SUNDRY NOTICES AND REPORTS ON WELLS
Do not use this form for proposals to drill or to re-enter an abandoned well. Use form 3160-3 (APD) for such proposals.

NEWBERRY LS 2C

Change of Wellplan

Conoco Inc. requests to change this well from "air drilled" to "mud drilled". A revised well plan and cement plan are attached herewith.

DRILLING PROGRAM - NEWBERRY LS 2C

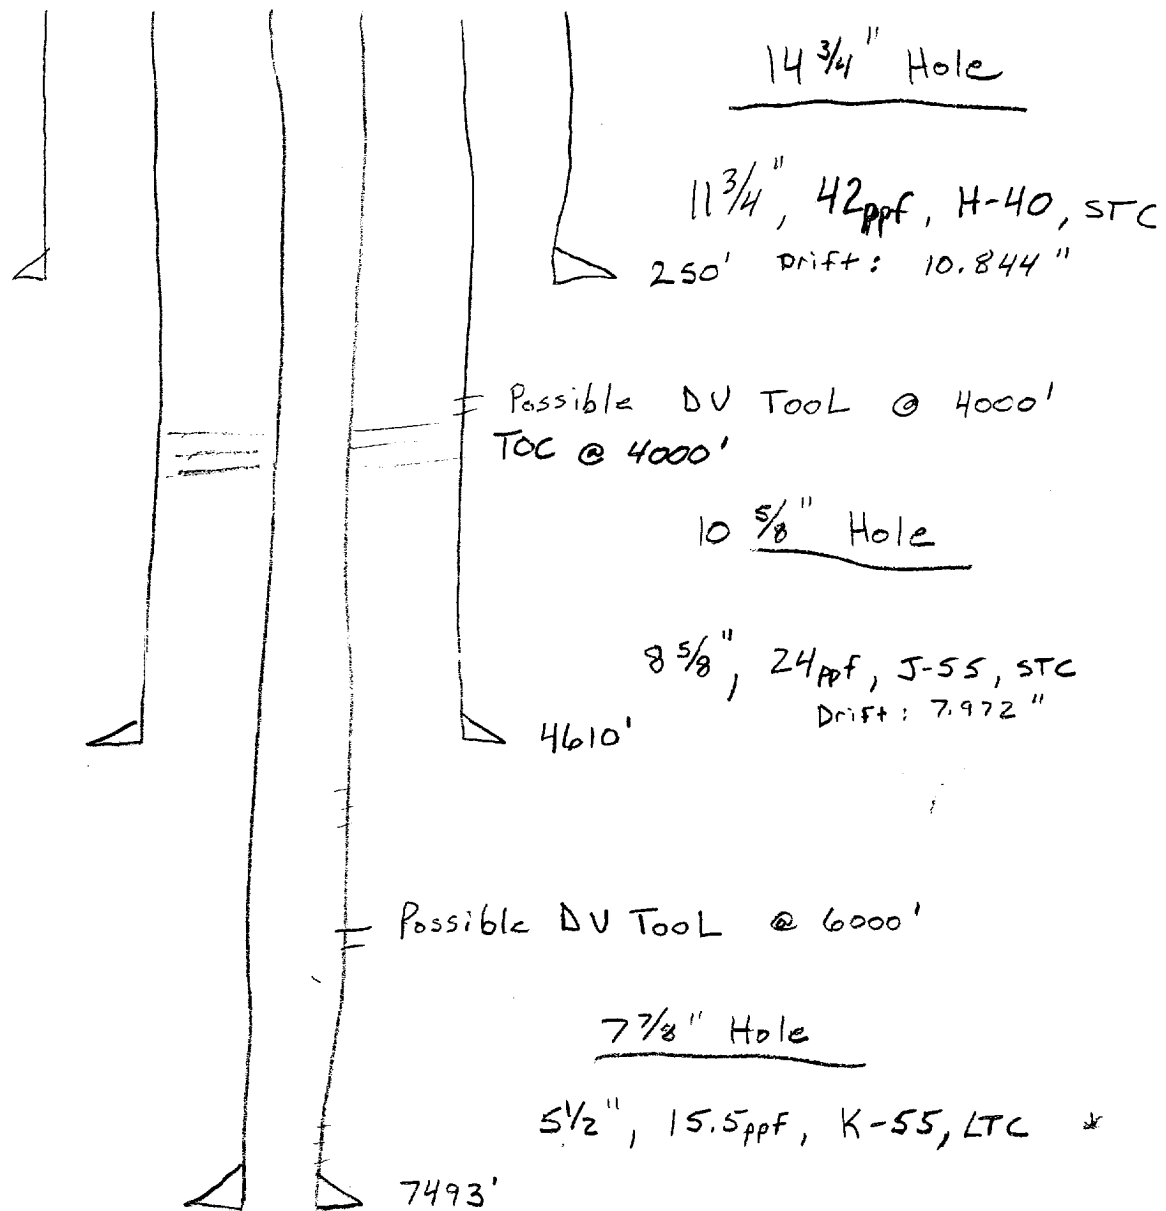
We drilled the Hamilton 1B & are currently still drilling the Moore LS 7B in this area and on both of them we have encountered extreme lost circulation. We've also encountered gas at surface after losing circulation.

We would like to change the casing design to run an intermediate string of casing to isolate the upper formations while drilling the lower Mesa Verde & Dakota formations.

Surface: 14 3/4" Hole - TD @ 250'
11 3/4", 42 ppf, H-40, STC casing set @ 250'

Intermediate: 10 5/8" Hole - TD @ 4610'.
8 5/8", 24 ppf, J-55, STC casing set @ 4605'
If hole conditions (lost circulation) dictate we will run a DV tool @ 4000' and cement in two stages.

Production: 7 7/8" Hole
We will drill out with air to ~7350'. At that point the hole will be loaded with mud and drilled to TD @ 7493'.

5 1/2", 15.5 ppf, K-55, LTC casing set @ 7488' (long string back to surface).
If hole conditions (lost circulation) dictate we will run a DV tool @ 6800' and cement in two stages.
